Addendum No. 2
October 16, 2023

Project: **Harrisburg South Middle School Theatre Addition**
Harrisburg, South Dakota
Architecture Incorporated Project #3024

Scope of this Addendum:

8 HSS BEAM TO CONCRETE WALL EMBED
1 1/2" = 1'-0"

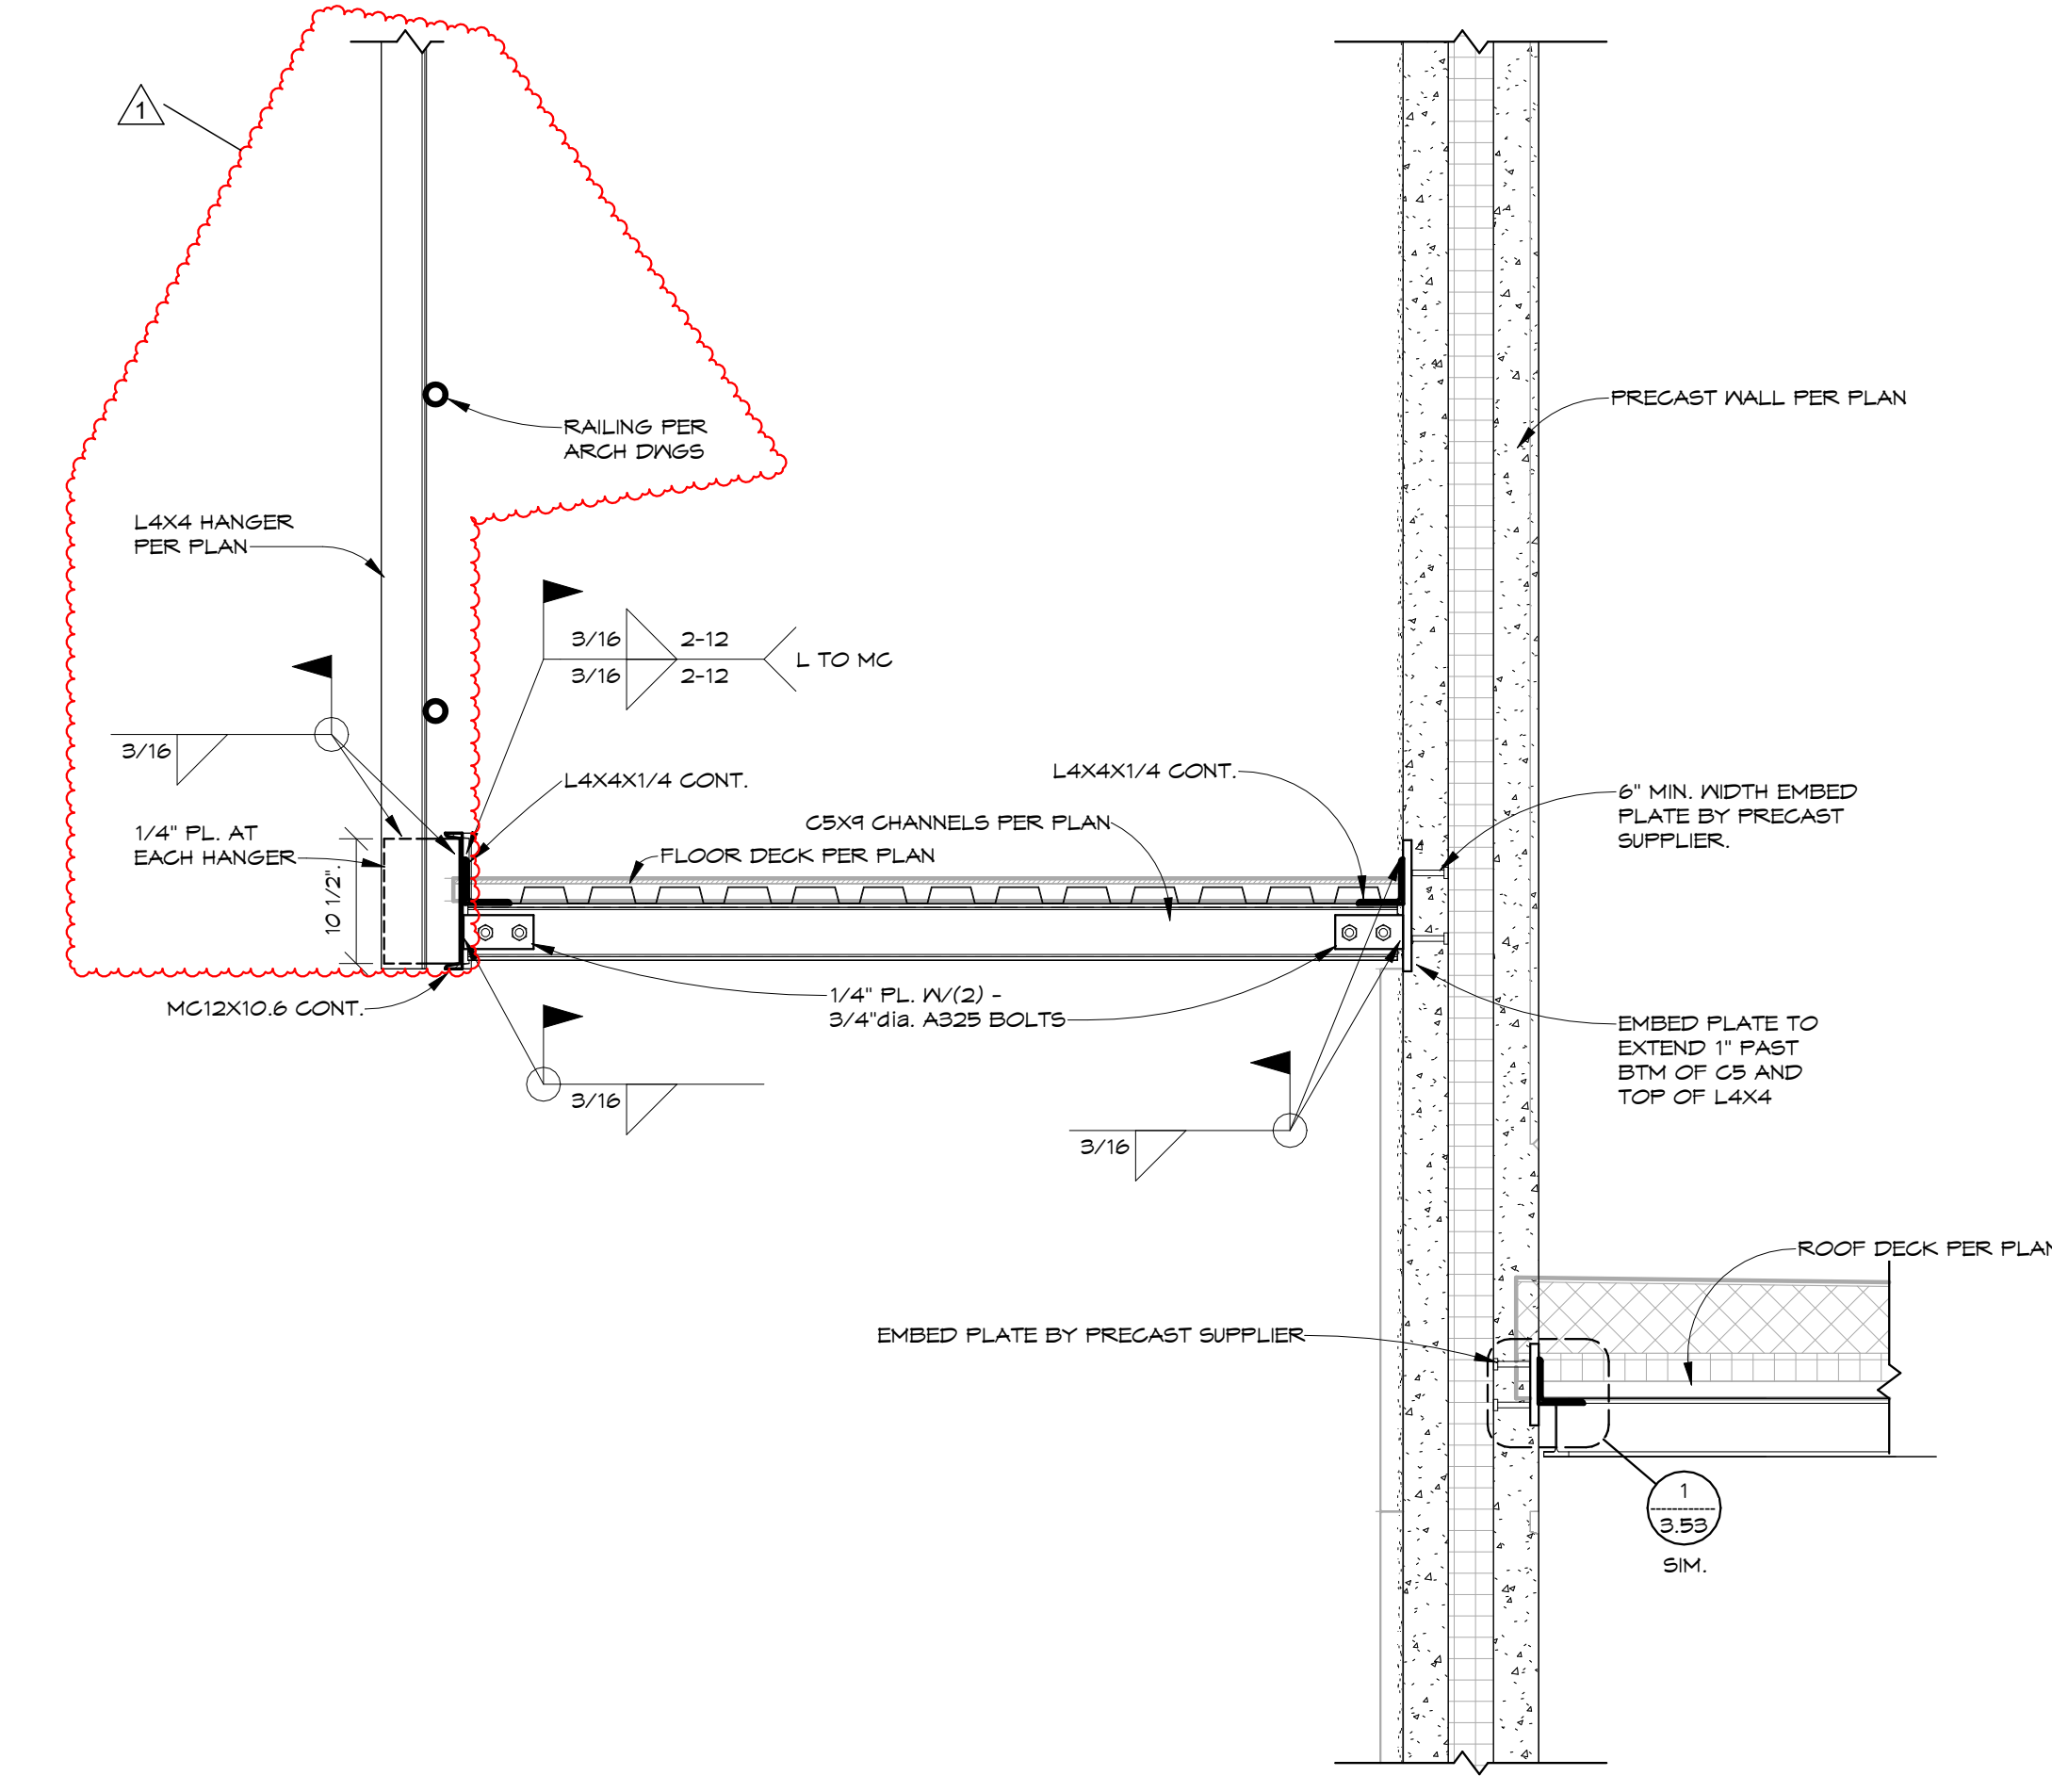
- a) DETAIL 8: Add guardrail pipes per architectural drawings. See revised sheet.

5 PENTHOUSE SOUTH WALL
3/4" = 1'-0"

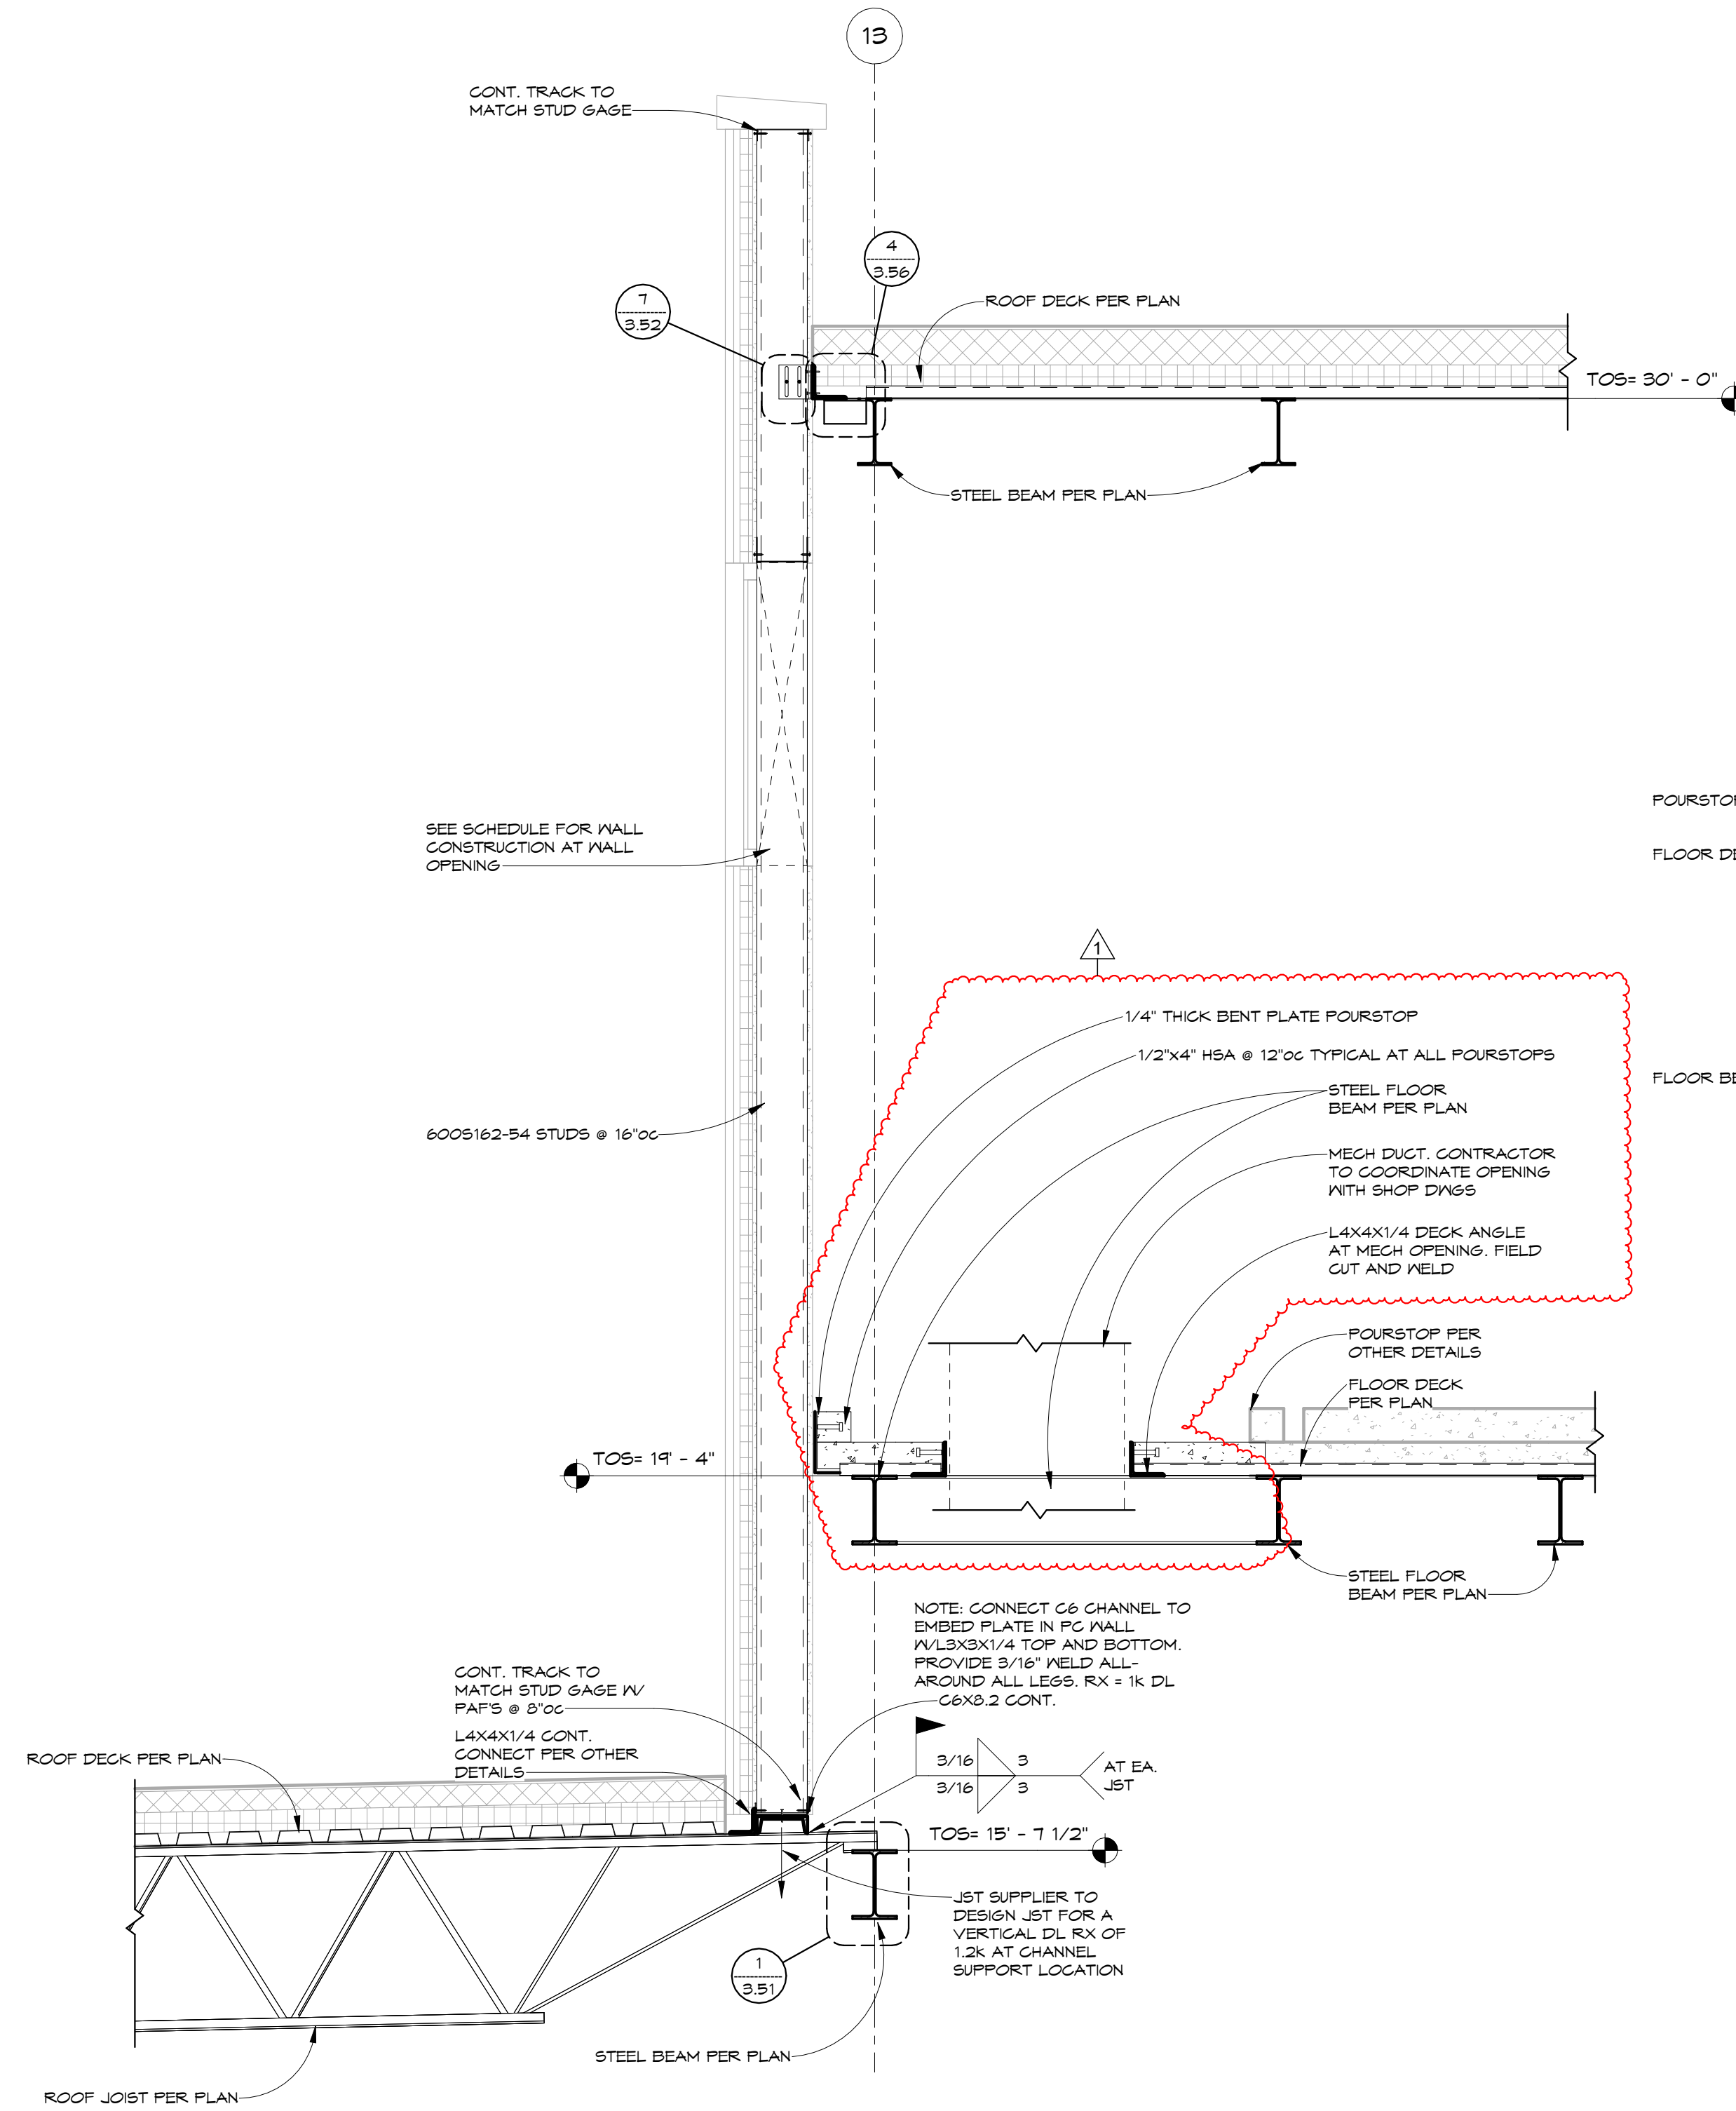
- a) DETAIL 5: Add floor framing around ducts per revised sheet.

DEMOLITION FLOOR PLAN - AREA B

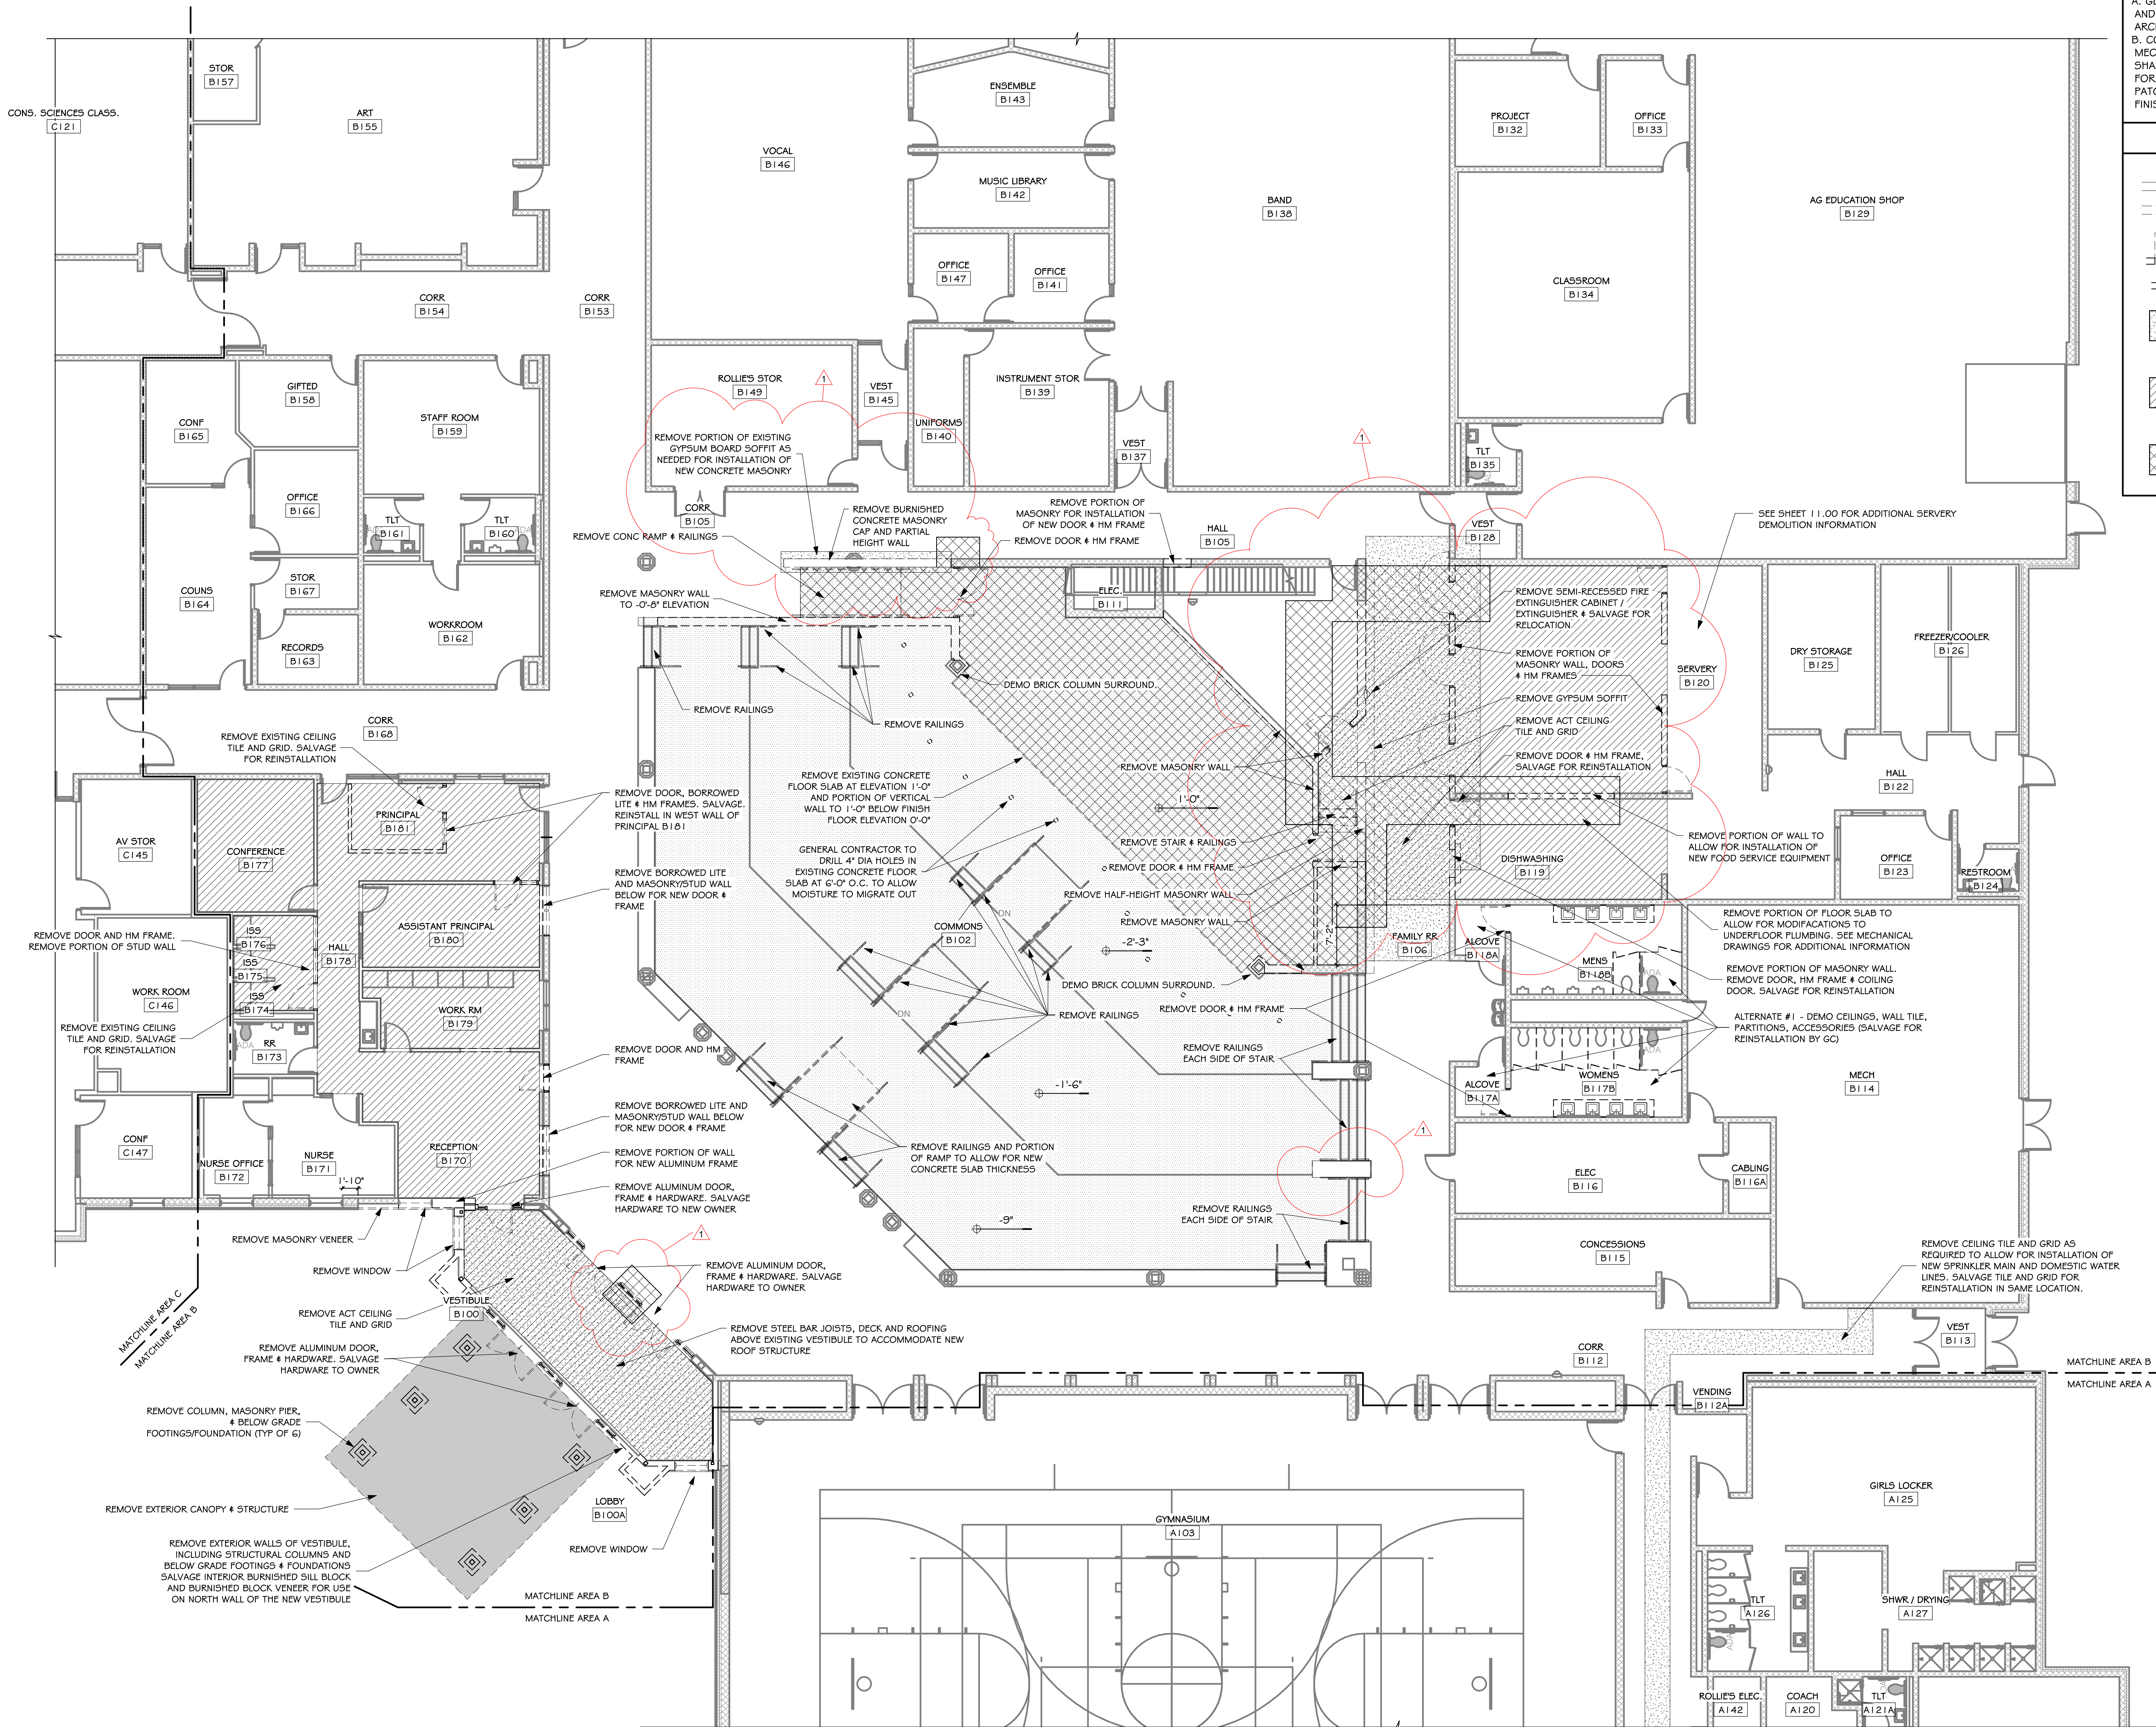
- a) Stage area - General contractor to remove all rigging, tracks, and drapes. The owner will remove the projection screen.
- b) See attached revised drawing sheet 4.00B dated 10-16-23 for removal of concrete floor slab to allow for installation of new concrete pad footings, underfloor waste lines, floor sinks and electrical floor boxes. See structural, mechanical, and electrical drawings for additional information/locations that may not be shown here.

- c) Remove floor slab in main entrance vestibule B100. (Entire Vestibule is to be removed to allow for installation of new expanded Vestibule).
- d) See attached revised drawing sheet 4.00B dated 10-16-23 for removal of low masonry wall on north side of ramp (that is being removed) in Corridor B105.
